CITY OF ALBUQUERQUE

**Re: Lot 11 Block 9 Unit 18 Volcano Cliffs SAD 228
6524 Papagayo Rd. NW
G&D Plan Date: 5/12/2020 (D10D003I11)
Pad Certification Date: 6/30/2020
CO Certification Date: 9/29/2022**

Based on the Certification received on 9/22/2022, the site is not acceptable for release of Certificate of Occupancy by Hydrology until the comments are addressed.

GRADING AND DRAINAGE PLAN

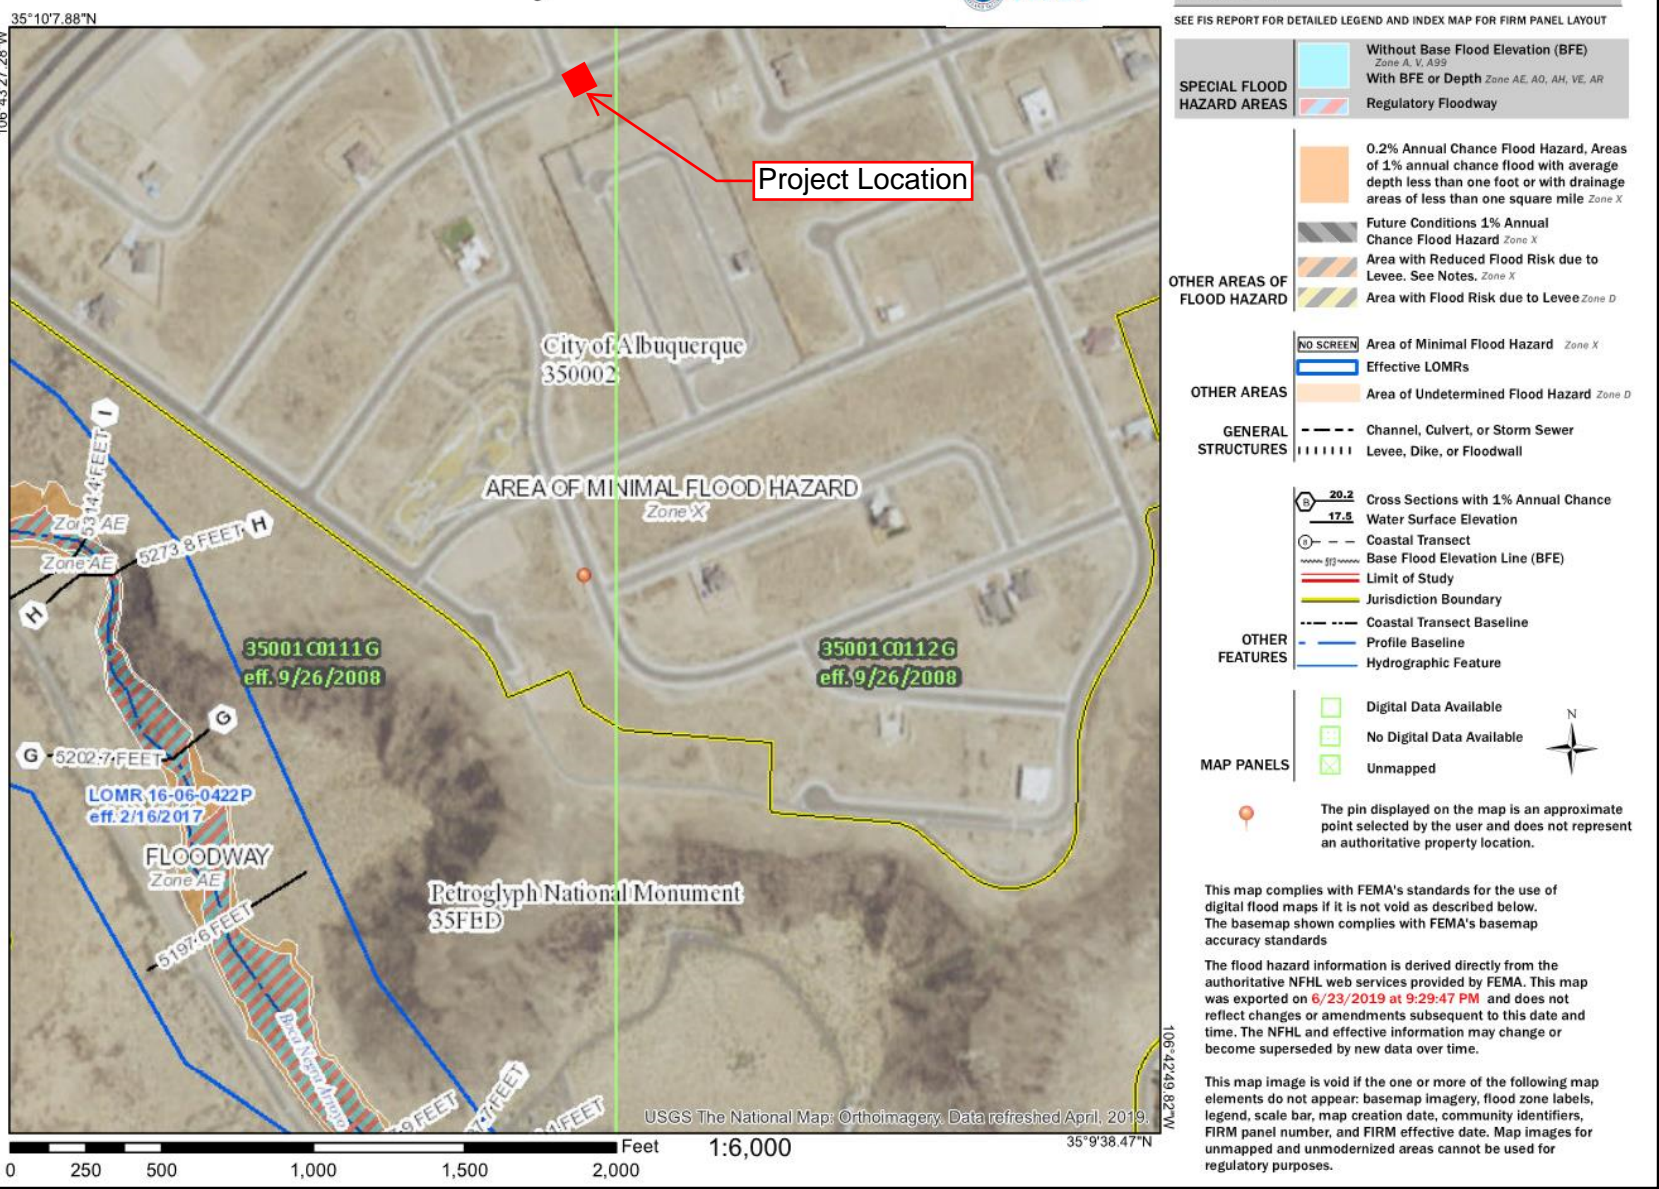
- Provide swales on the rear yard and the side yards by the cmu walls. All the flows from the roof are putting pressure on the cmu walls, this is not allowed.
